LIGO CALIFORNIA INSTITUTE OF TECHNOLOGY
 MASSACHUSETTS INSTITUTE OF TECHNOLOGY

PART NAME
CUSTOM CABLE SPECIFICATION V25W

DESIGNER	DATE	SIZE	DWG. NO.	REV.
DRAFTER	E.BROWN	MAR/2/2010	D	D1000233-v1
CHECKER				
APPROVAL

V25W CABLE ASSEMBLY CIRCUIT SUMMARY
V-DB25 M/S-22,23-2_DB9 F/X

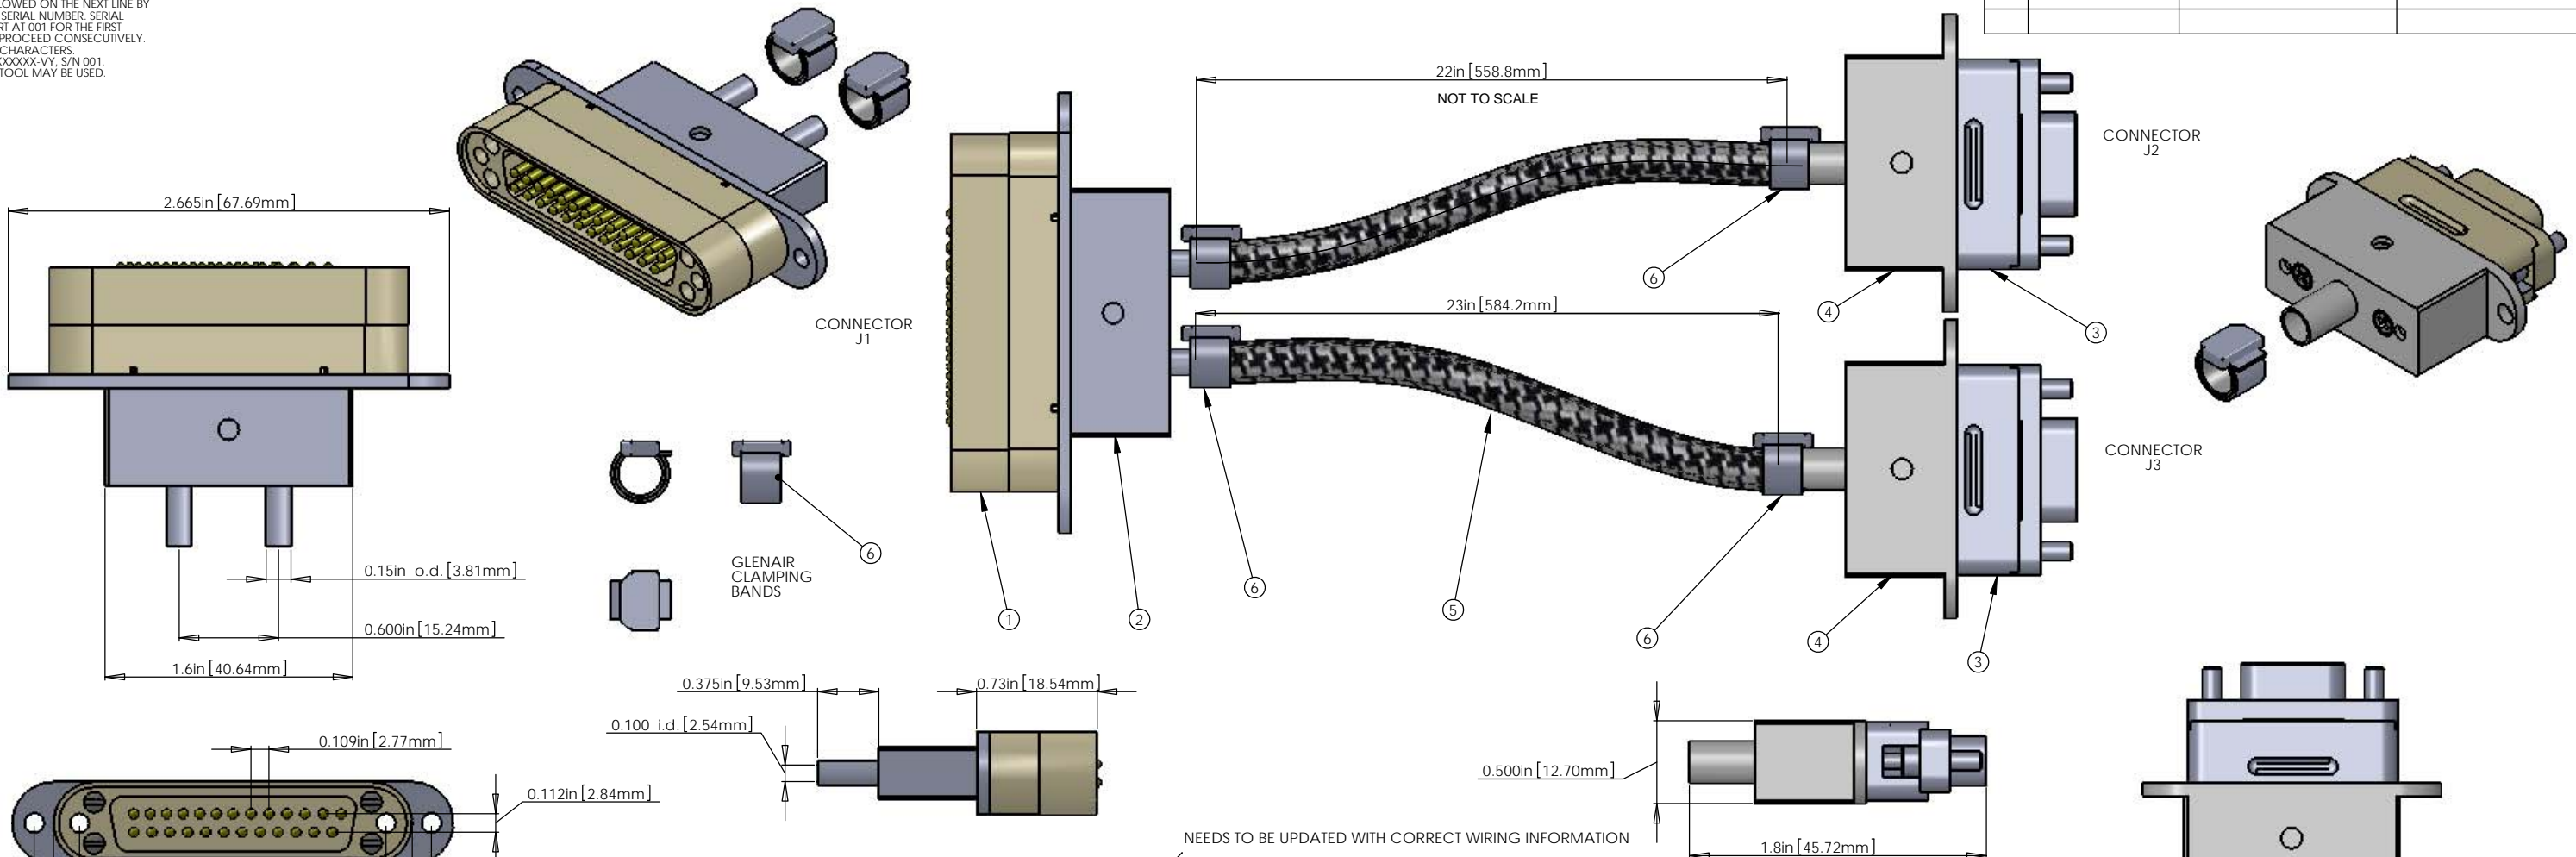
NEEDS TO BE UPDATED WITH CORRECT WIRING INFORMATION
